SUNDRY NOTICES AND REPORTS ON WELLS
Do not use this form for proposals to drill or to re-enter an abandoned well. Use form 3160-3 (APD) for such proposals.

| 1. Type of Well <input type="checkbox"/> Oil Well <input type="checkbox"/> Gas Well <input checked="" type="checkbox"/> Other: COAL BED METHANE | | 8. Well Name and No. BUENA SUERTE 4 G COM 1 |

Plug and Abandonment Procedure

Buena Suerte 4 G Com 1

Proposed Wellbore P&A Diagram
DJR Operating, LLC
Buena Suerte 4 G Com 1
 API # 30-045-28506
 SW/NE, Unit G, Sec 4, T25N, R11W
 San Juan County, NM

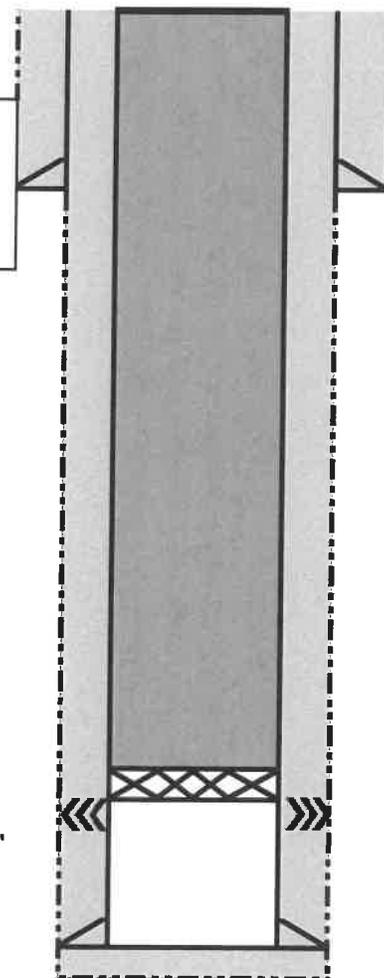
- Please ensure that the tops of the Pictured Cliffs and Fruitland formations as well as the entire Ojo Alamo aquifer, identified in this report, are isolated by proper placement of cement plugs. This will protect the freshwater sands in this well bore.

Proposed Wellbore P&A Diagram
DJR Operating, LLC
Buena Suerte 4 Com 1T
API # 30-045-32007
SW/NW, Unit E, Sec 4, T25N, R11W
San Juan County, NM

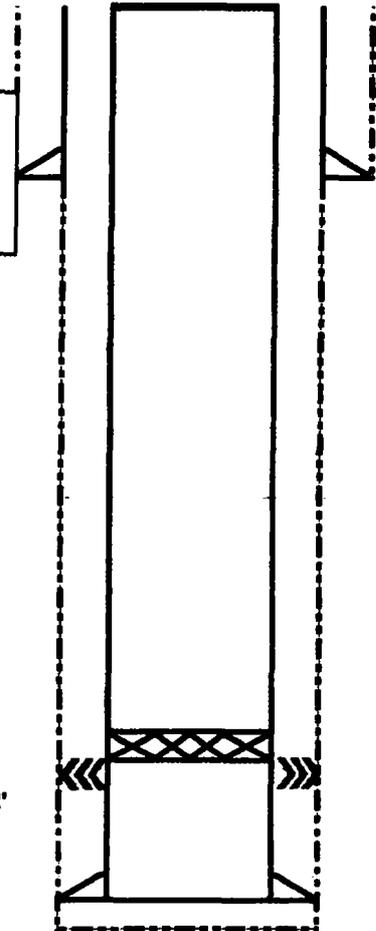
- Please ensure that the tops of the Pictured Cliffs and Fruitland formations as well as the entire Ojo Alamo aquifer, identified in this report, are isolated by proper placement of cement plugs. This will protect the freshwater sands in this well bore.
